SEWAGE DISPOSAL TESTING

PERCOLATION CERTIFICATION
SCHREMP PROPERTY
5th Election District
Howard County, Maryland
Scale: 1" = 100' Date 1-7-83 Pnn: TGH

RE: F-83-76 Schremp Property

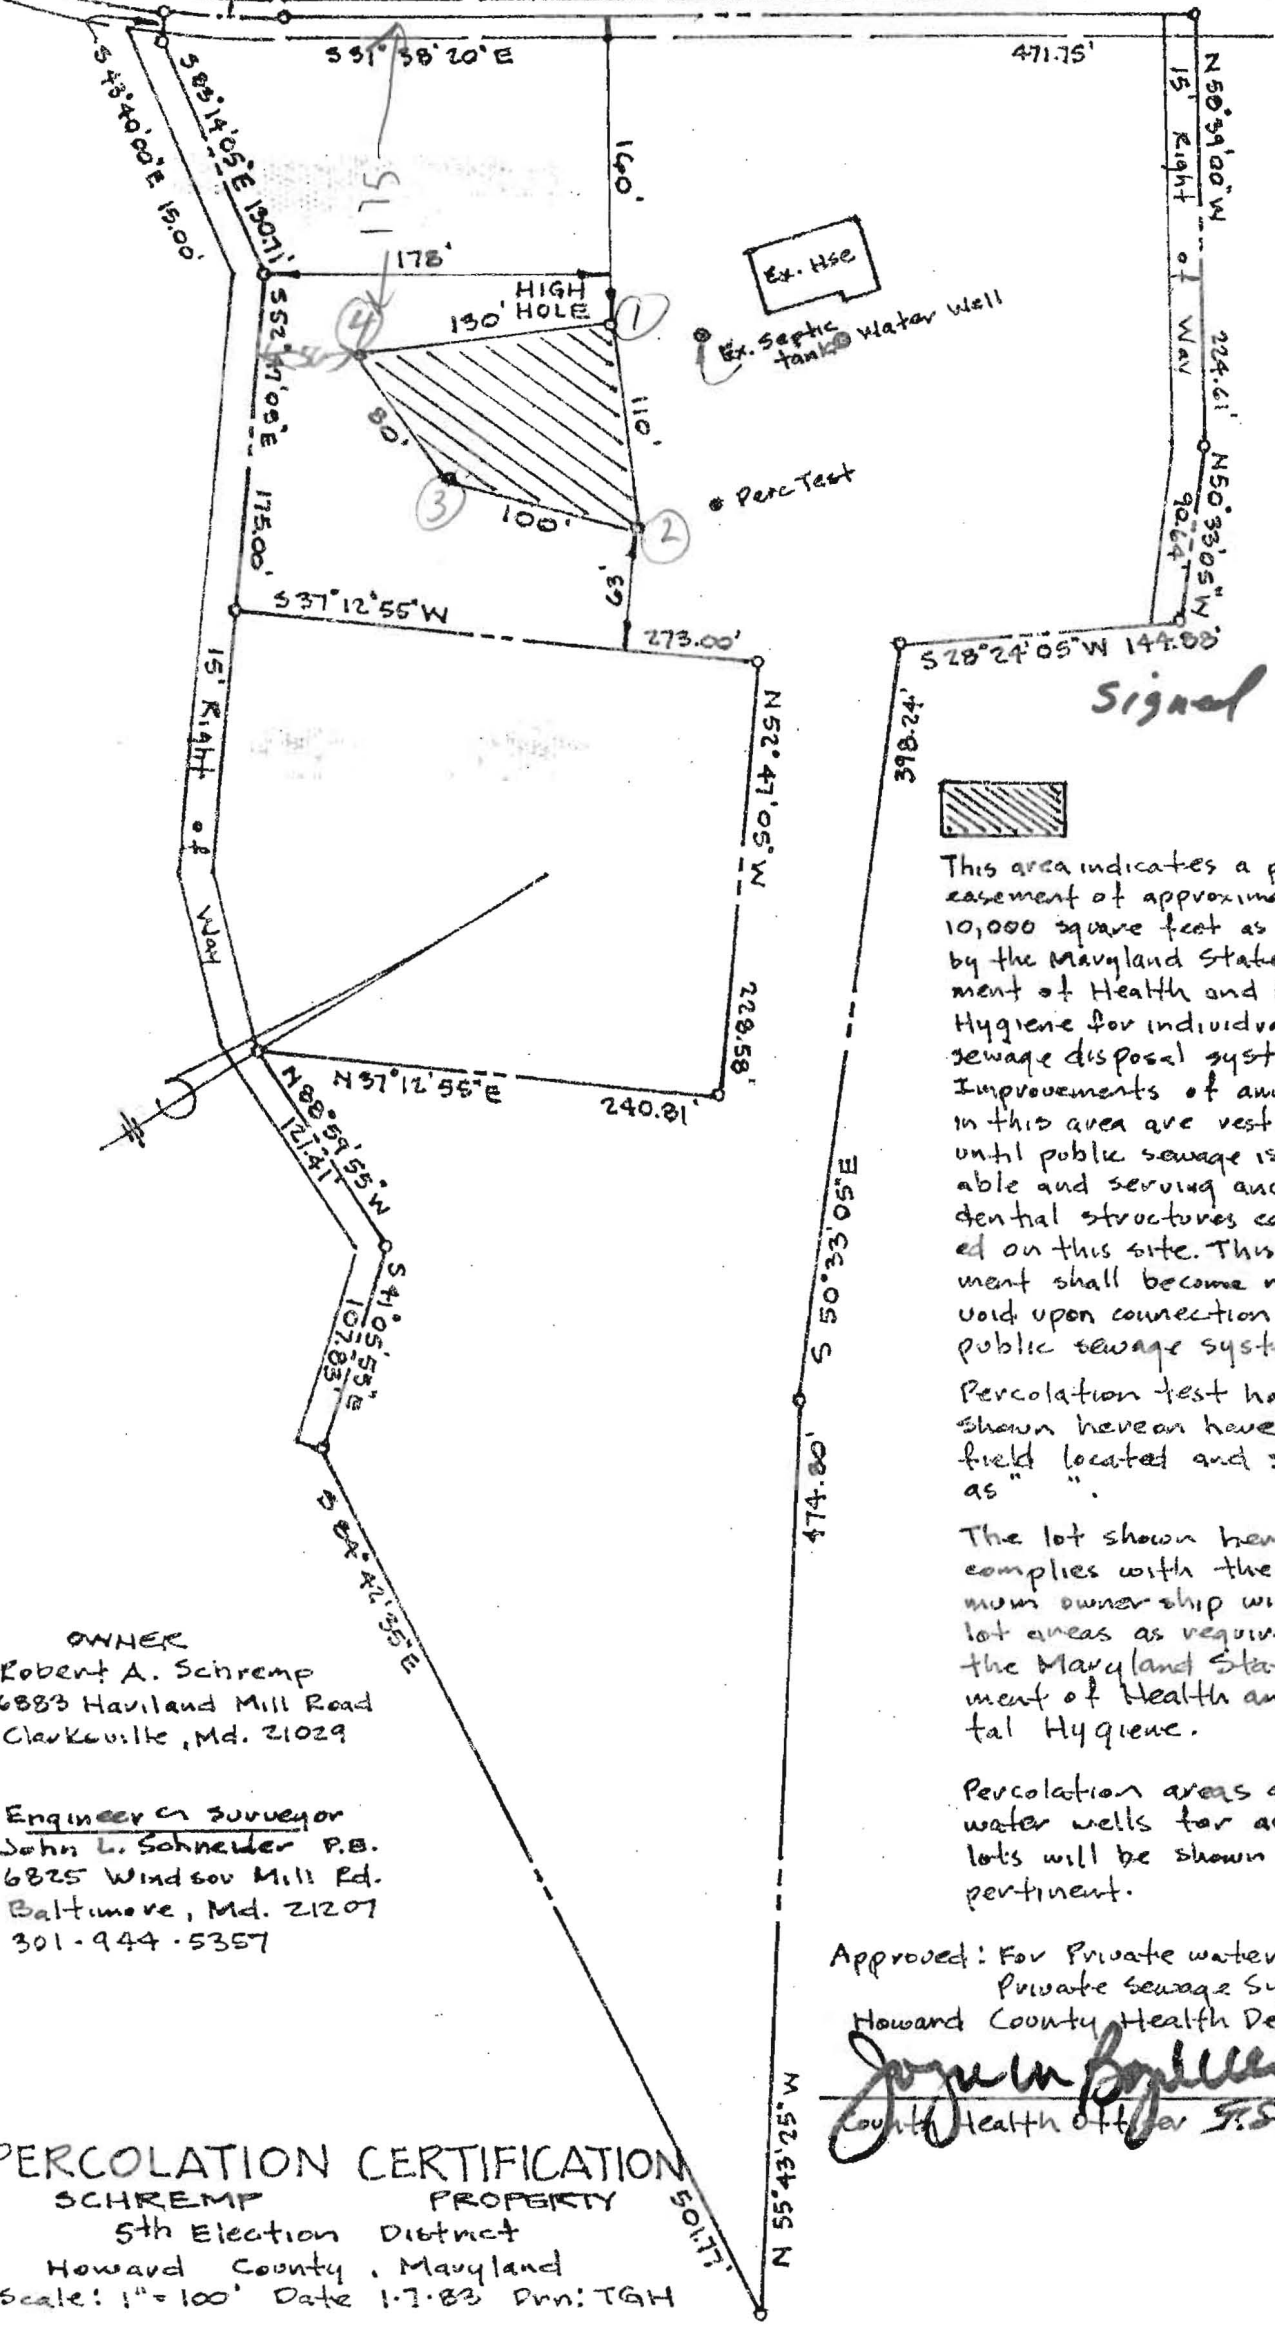
REASONS FOR REJECTION OR HOLDING 11/15/82 PERC OK
HOLD FOR LAND SUBDIVISION PLAT (R1)

PERCOLATION CERTIFICATION
SCHREMP PROPERTY
5th Election District
Howard County, Maryland
Scale: 1"=100' Date 1-7-83 Dwn: TGH

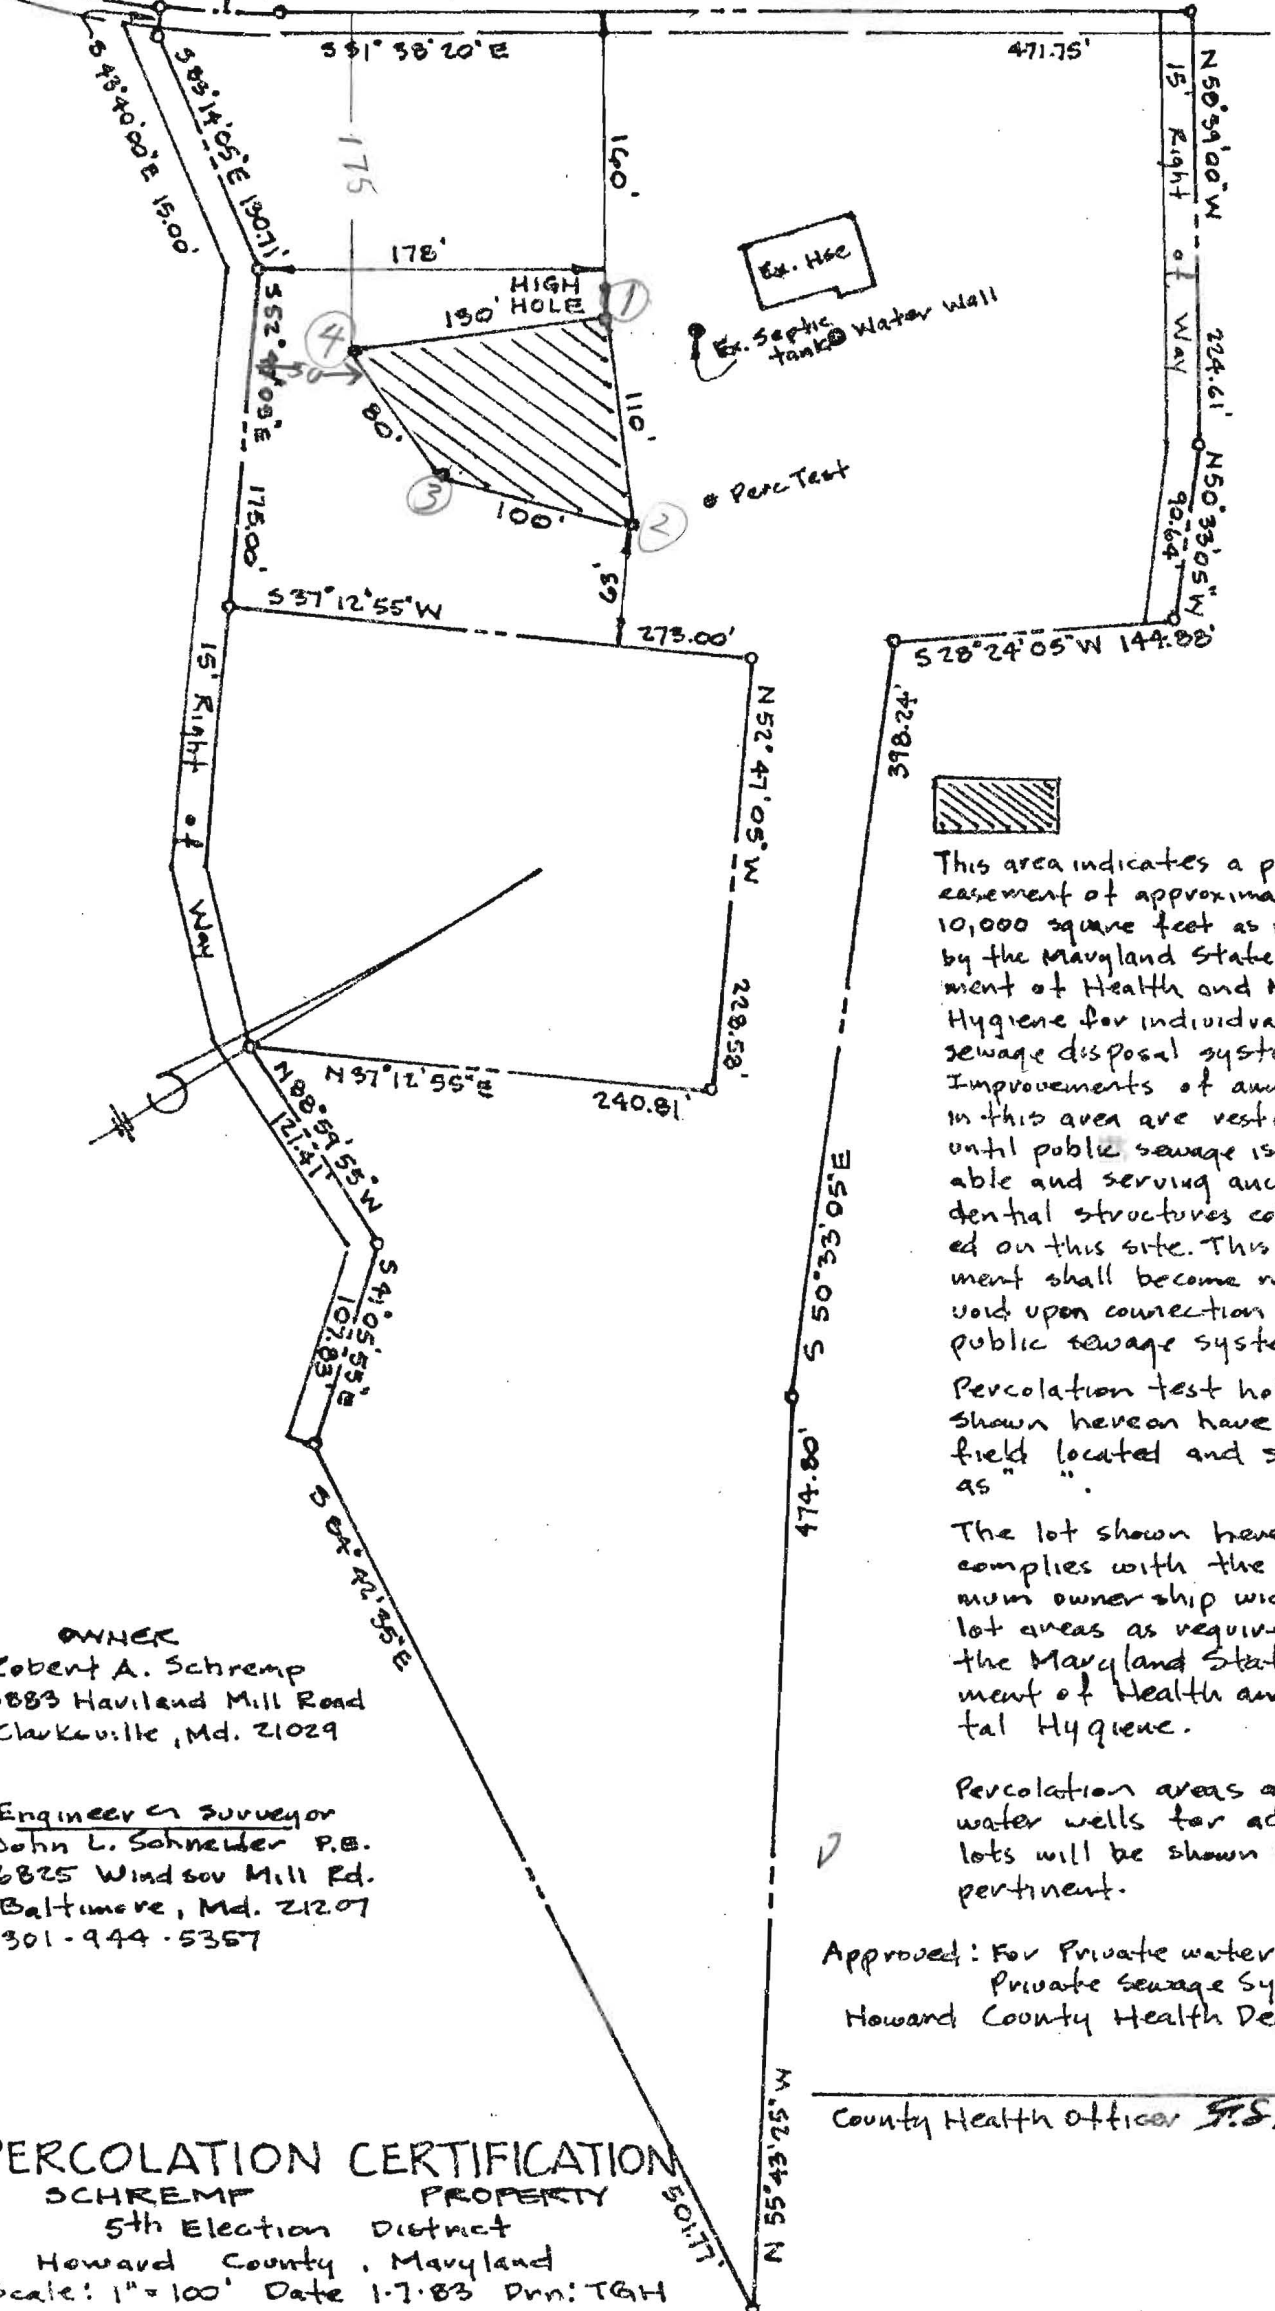
11/28/83 FINAL APPROVAL OF
THESE SPECS PENDING FINAL
APPROVAL OF FINAL SUBDIVISION PLAT.
3 BEDROOMS - 1000 GALLON TANK
4 BEDROOMS - 1250 GALLON TANK

6/2/83 FINAL PLAT SIGNED.
SPECS OK

SKETCH FOR SEPTIC PERC TESTS

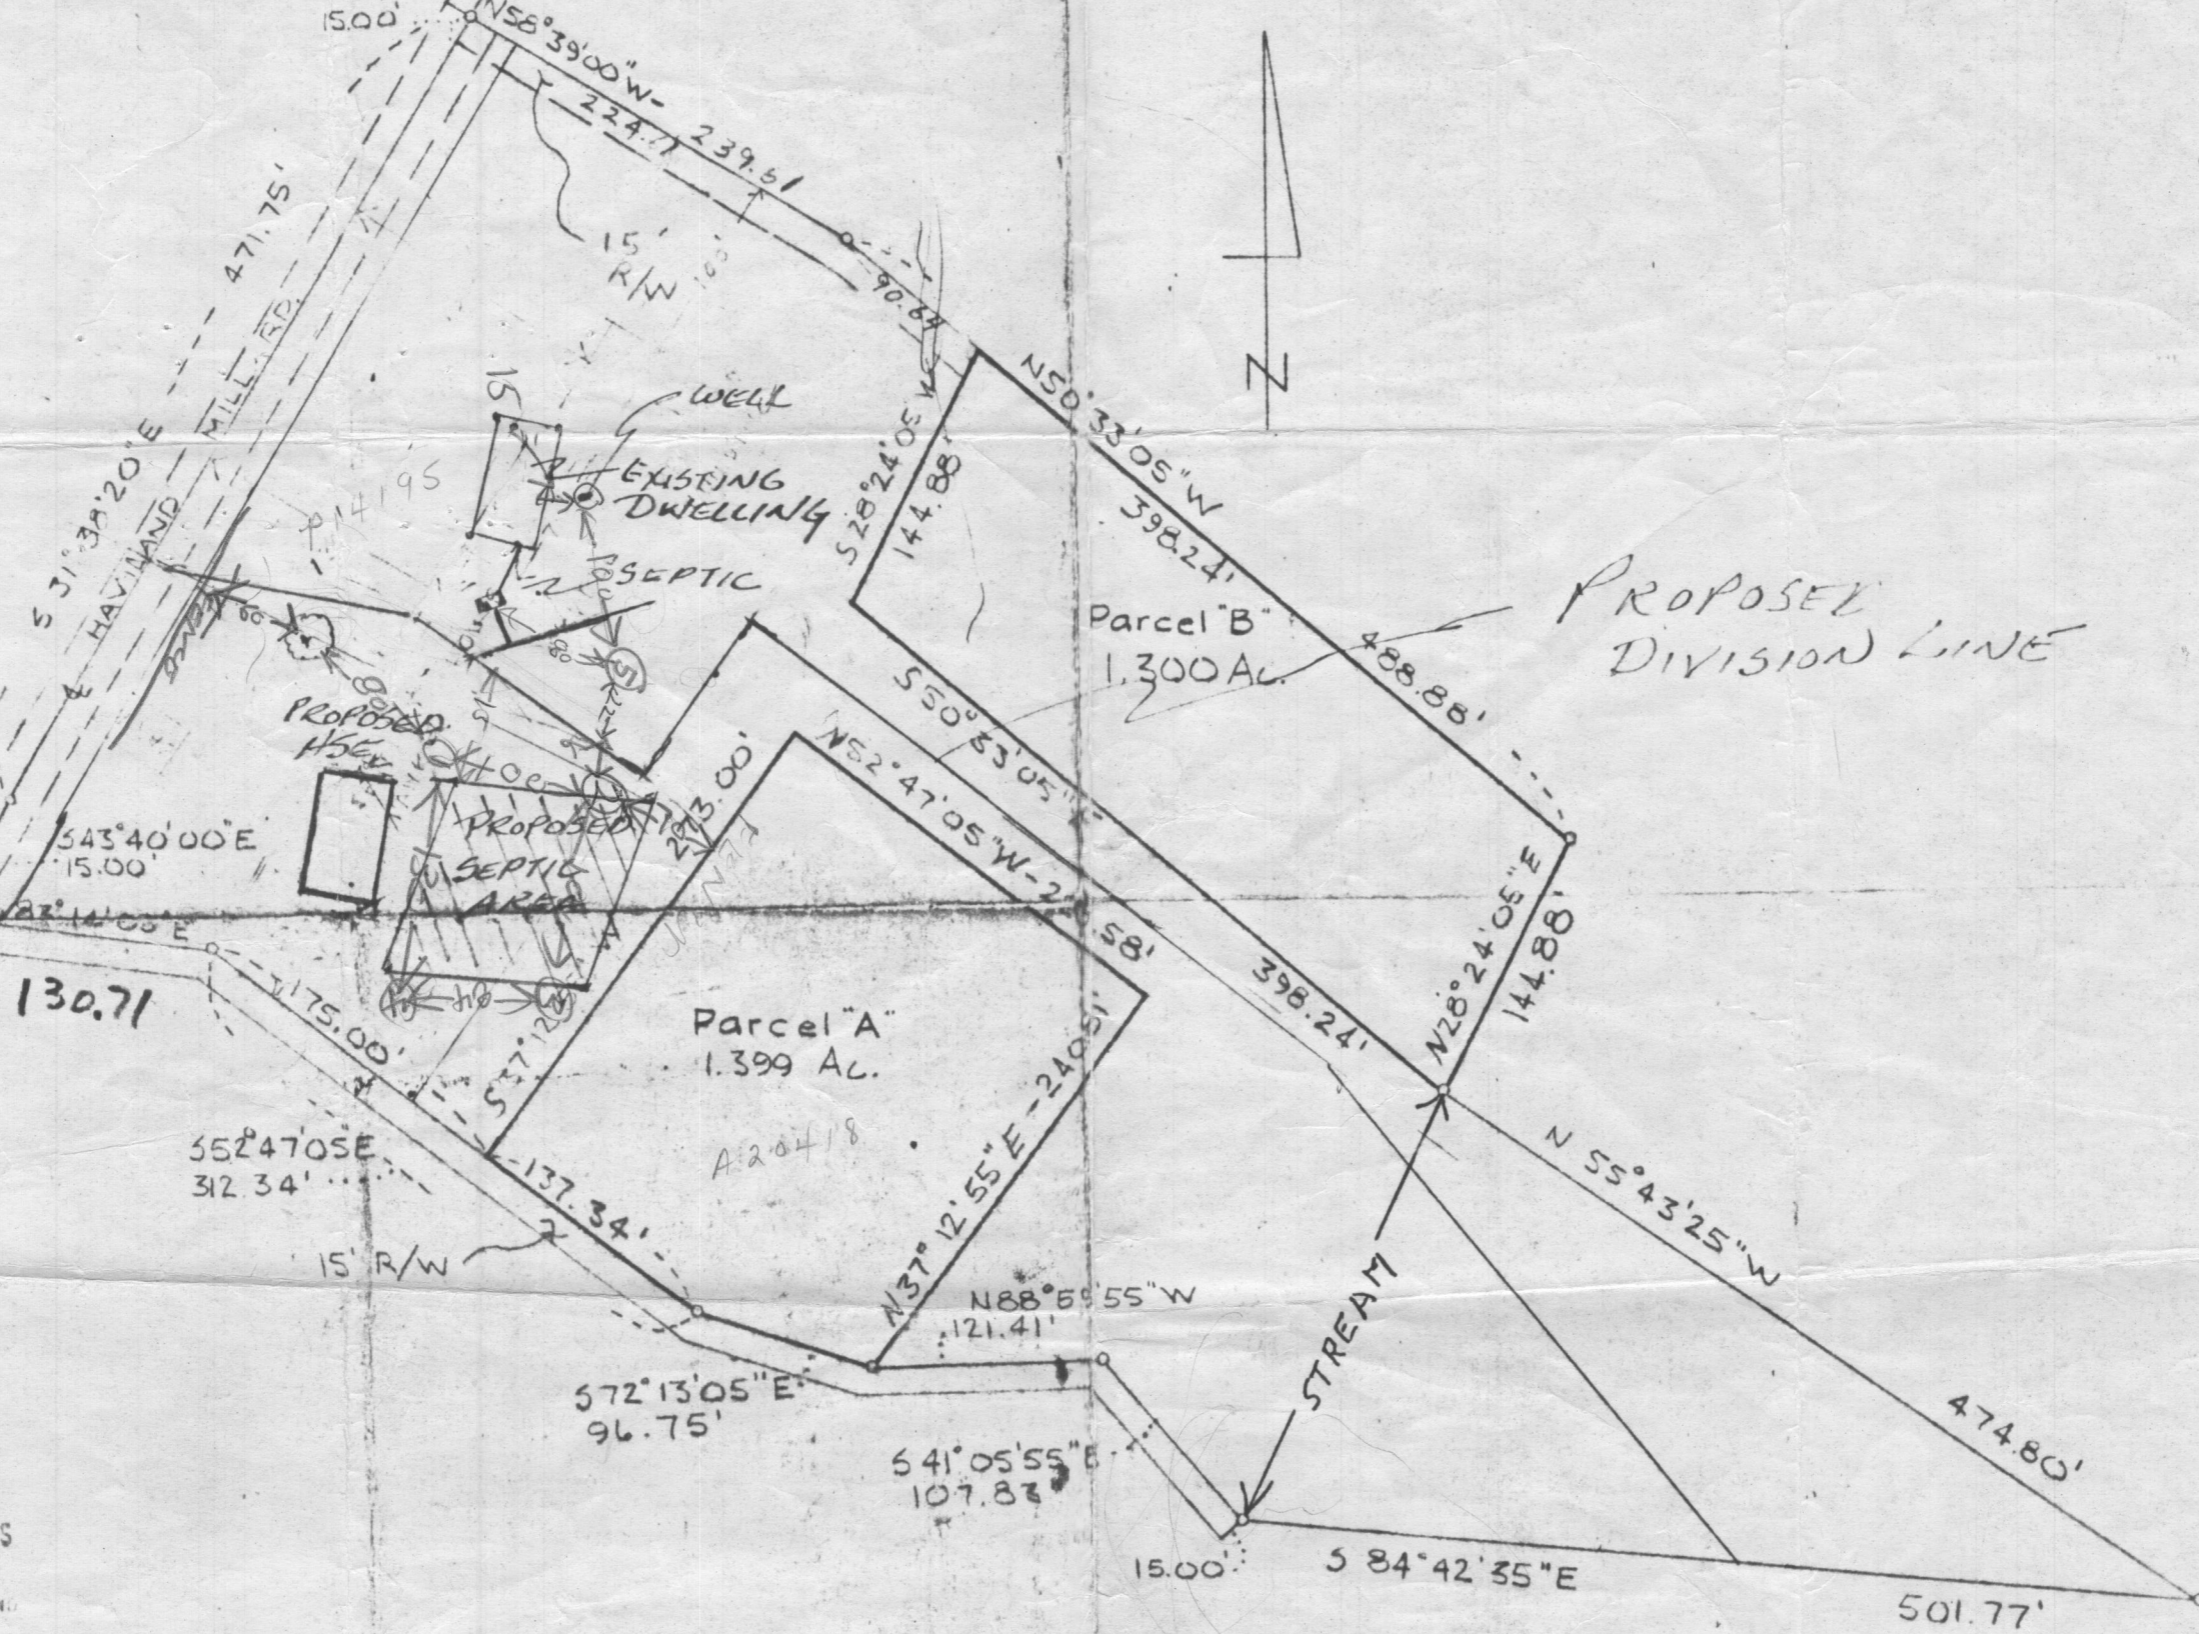
OTHER COMMENTS: ① Health Dept. signature block must indicate approval for private water & private sewerage systems & ② Note #1 (sewage easement statement) is incomplete - see page 56 of Subdivision Regulation
